NEDO-32205-A
Class I
February 1994
Revision 1

**10CFR50 APPENDIX G
EQUIVALENT MARGIN ANALYSIS
FOR LOW UPPER SHELF ENERGY
IN BWR/2 THROUGH BWR/6 VESSELS**

Licensing Topical Report for
the BWR Owners' Group

Figure 5-5 Flaw Stability Criterion Evaluation for Axial Flaw with Linde 80 Flux Weld J-R Curves

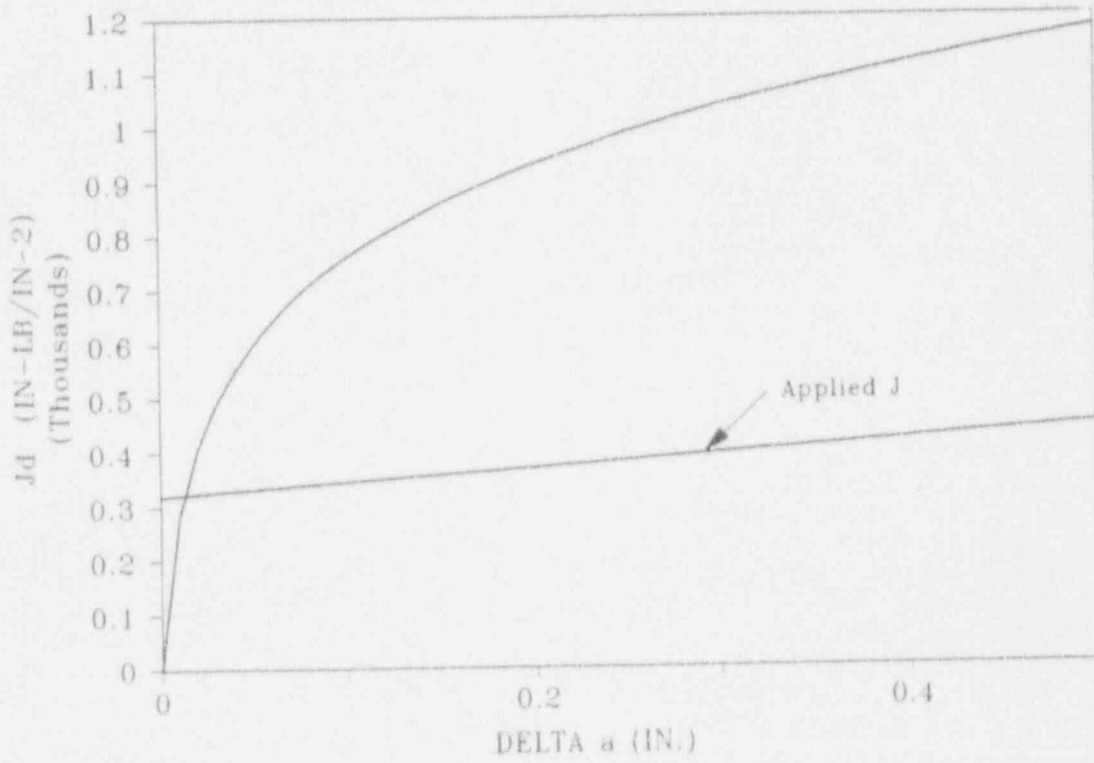
The BWROG chose the Linde 80 Copper-Fluence Model without thickness terms from NUREG/CR-5729 for their Linde 80 welds. Since the final results presented in Figure 5-5 of the topical report show large margins between the applied J curve and the J-R curve for both criteria, the staff has concluded that checking all possible J-R models for Linde 80 welds is not necessary and the results for Linde 80 welds are acceptable.

Figure 6-6 Applied Axial Flaw $J_{0.1}$ Values for Level C and SA302B J-R Curves

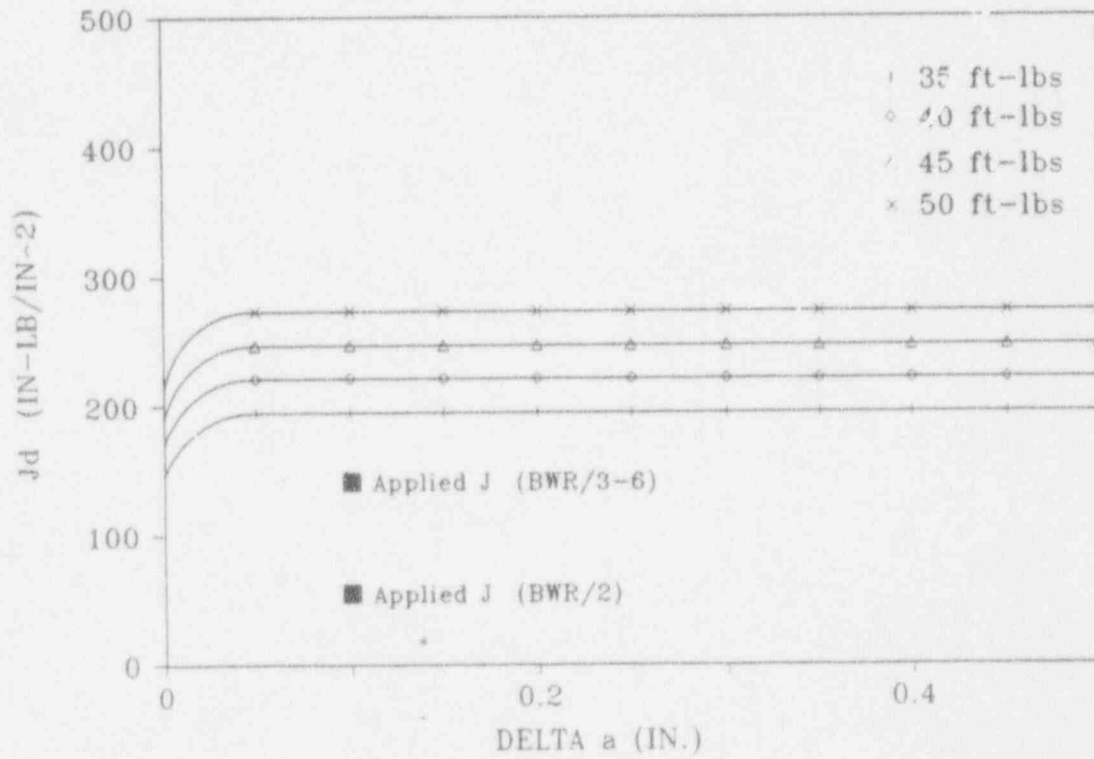
By comparing the final results for Level C (Figure 6-6 of the topical report) and Level D loading (Figure 6-10) for SA302B plate, the staff agrees that Level A and B results are controlling and the same conclusion can be applied to other types of material also. Therefore, the minimum permissible EOL USE values, listed under the heading "Code Case N-512 EOL USE" in Table 1, are actually results from Level A and B analyses.
